Request for Approval of Design Exception(s) to AASHTO Guidelines

County: LEXINGTON/RICHLAND
Project ID Number: P043329
Route Number: I-126
Route Name: I-126
From: MM 0.00
To: MM 0.70
Length 0.7 (miles)
Letting Date: _____
Work Description: Widening of I-126
Functional Classification: Interstate
Context: (Urban ☑ / Rural ☐)
Local Road/Street Group Designation (if applicable): (1 ☐ / 2 ☐ / 3 ☐ / 4 ☐)
Type of Terrain: (Level ☐ / Rolling ☑ / Mountainous ☐)
Design Speed: 60 (mph)

Attachment A – Design Exception

TRAFFIC ENGINEERING SAFETY REVIEW

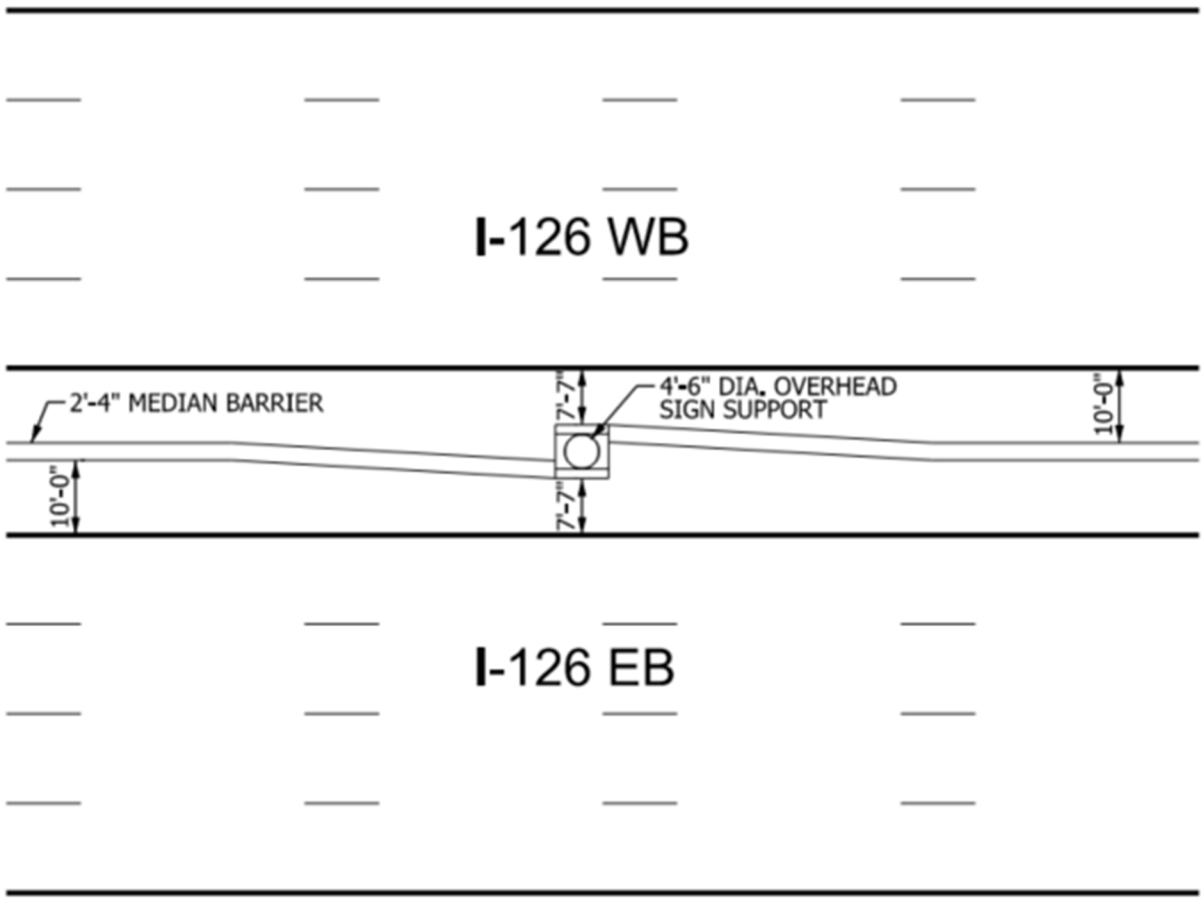
The Carolina Crossroads Phase 3D Project consists of all work necessary to complete the design and reconstruction of the I-26 and I-126 system interchange and I-26 bridges over the Saluda River and CSX Railroad, in Lexington and Richland Counties. Work will include design and construction of interstate widening, riverine bridges, railroad bridges, retaining walls, and related roadway appurtenances. This design exception would allow narrow shoulders at very limited locations (spot locations) to accommodate overhead sign supports that are constructed within the shoulder areas. Due to the location of the overhead structure supports, the variance would be allowed in the inside shoulder. I-126 is a multilane interstate that use concrete barrier to divide the directions of travel. The existing inside shoulder width along this route within the Phase 3D project limits is approximately 4.75'. Per AASHTO *A Policy on Geometric Design of Highways and Streets, 7th Edition (2018)* section 8.2.4, on freeways with six or more lanes, the paved width of the right and left shoulders should be 10 ft. Assuming an overhead sign structure foundation diameter of 4’-6”, the resulting inside shoulder width would be reduced to 7’-7”. This design exception will allow shoulder width reductions at spot locations to be reduced to a minimum of 7’-7”’ at these specific locations.

The design exception is requested to allow spot locations where the shoulder would be less than AASHTO requirements (approximately 7’-7” at a minimum) but greater than the existing 4.75'. Stopping sight distance would still be provided per the contract documents for the design-build project. A predictive crash analysis was performed by the SCDOT Traffic Safety office in October 2019 as part of CCR Phase 2 and found no substantial increase in crash volumes between a 10’ shoulder and 8’ shoulder in either 5-lane or 4-lane sections. See Appendix A for Traffic Engineering Safety Review report.

To provide a 10' inside shoulder, the crown point of I-126 in both directions would need to be shifted approximately 2’-5”. This would then result in deflections of the horizontal alignment and introduce curves or tapers into the mainline geometry which is undesirable. Other strategies such as reduction in lane width to provide shoulder width were ruled out due to the traffic volume and truck percentage. Costs associated with the elimination of the design exception are negligible, however, this design exception follows project precedence with Phase 1, Phase 2, and Phase 3C where inside shoulder width design exceptions were approved and provides consistent application of shoulder width treatments throughout the entire Carolina Crossroads program.

5-lane 12'-4.75' taper shoulders

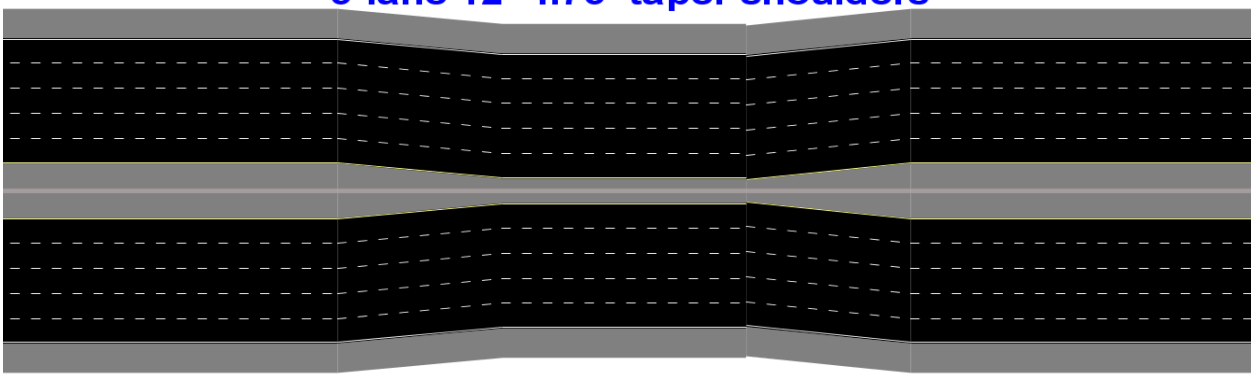
In order to complete the requested review, a sample interstate corridor similar to the proposed cross sections provided with the request was modeled. This sample model consisted of a 0.25 mile section of 4-lane interstate and 5-lane interstate. Projected AADT's were input as 90,000 and 100,000 VPD in the years 2020 and 2040 for the 4-lane section; along with 120,000 and 130,000 VPD for the 5-lane section. In order to get a baseline prediction of crashes for comparison, a maximum straight shoulder width of 12' was used to estimate a total number of crashes over a ten year period for the given conditions of each theoretical corridor. Subsequent crash totals were modeled by reducing the inside shoulder width for a section of the corridor to estimate the effects of a narrower inside shoulder at a point on the interstate due to interchange bridge piers and or barriers. The reduced shoulder widths were modeled for a length of approximately 225', of which 95' was the length of the fully reduced width, along with variable widths before and after this reduced width due to the leading and trailing tapers. These taper lengths started from a full 12' width shoulder, and tapered for a length of approximately 65'. The reduced shoulder widths that were sampled are as follows; 4.75', 6', 7', 8', 9', 9.75', 10', & 11' and are shown in the table below. Also shown is a sample plan view produced from the IHSDM software.

For the conditions outlined above and used in the IHSDM, results predict that there would be approximately 1 additional crash every 10 years in the worst case scenario of reducing the inside shoulder width from 12' to 4.75' for approximately 225'. There was practically no additional crash experience between the proposed 9.75' and minimum required width of 10.0'

Based upon these results with the provided input values, there does not appear to be any adverse safety effects at these point locations due to a reduction in shoulder widths.
